TECHNICAL BULLETIN
K196NAS2
05 NOV 2014

Service Action: Seatback Business Tray

XJ Range (X351)

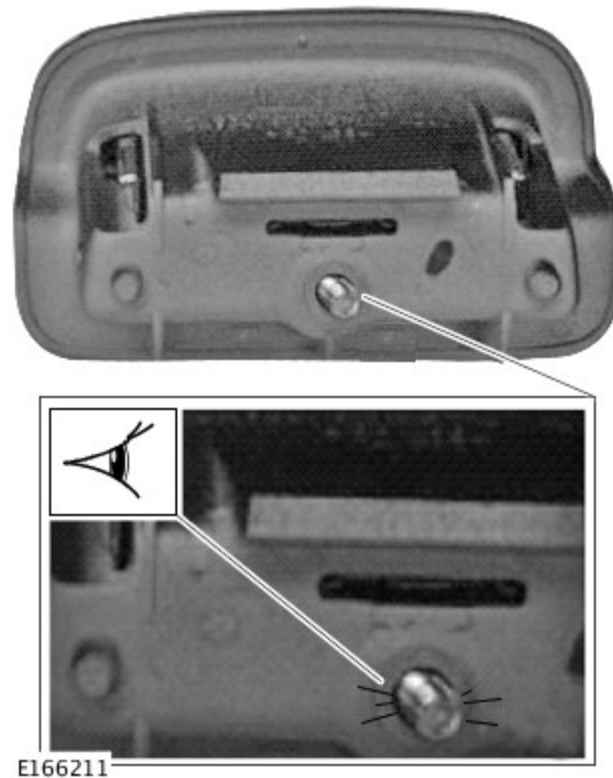
3. Inspect the business tray latch for cracks.

- If the latch is not cracked, continue to the next step.
- If the latch is cracked, continue to the next step using a **new** business tray latch.

E159920

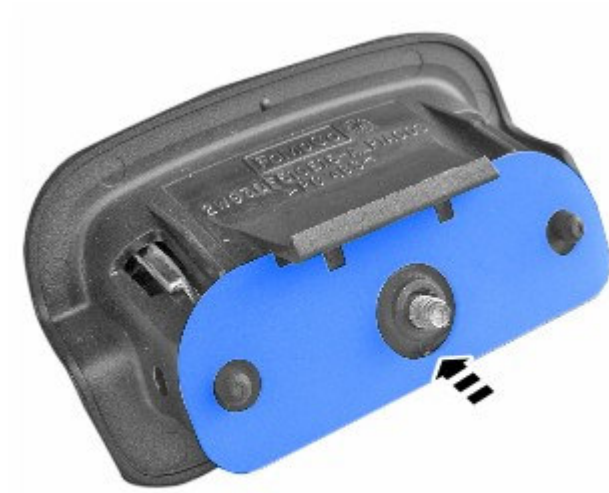
4. Install the new spacer.

- Torque: 1.8Nm
